PCN#20151006002 Conversion to smaller reel (13" to 7") and associated packing materials on Select Devices currently shipped in 13" reels Final Change Notification

PCN Number:			20151006002			PCN Date:	10/22/2015		
				smaller reel (13" to 7") and associated packing materials evices currently shipped in 13" reels					
Customor			_admin_team@list.ti.com			Quality Services	Proposed 1 st Ship Date:		1/22/2016
Change Type:									
	Assemb	ly Site		Des	ign			Wafer Bum	p Site
Assembly Process		Data Sheet			Wafer Bum	p Material			
Assembly Materials		Part number change			Wafer Bum	p Process			
Mechanical Specification			Test Site				Wafer Fab Site		
□ Packing/Shipping/Labeling			Test Process			Wafer Fab Materials			
						Wafer Fab I	Process		
PCN Details

Current Packing – 13 inch reel diameter

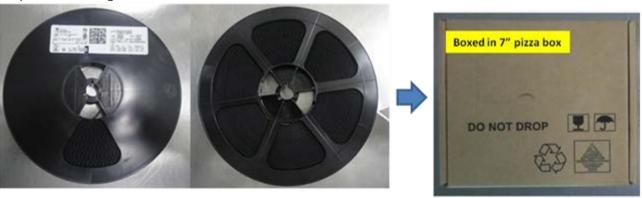
Conversion to a smaller reel size for selected product currently shipped in 13" reels with small reel quantities. The Moisture Barrier Bag (MBB) and pizza box will be switched to accommodate the smaller reel size. All new packing materials are qualified and currently in use for other products. Pack material differences are shown below:

Pack BOM	From	То	
Reel Diameter	13"	7"	
Pizza Box	4041330	4206831

Proposed Packing – 7 inch reel diameter
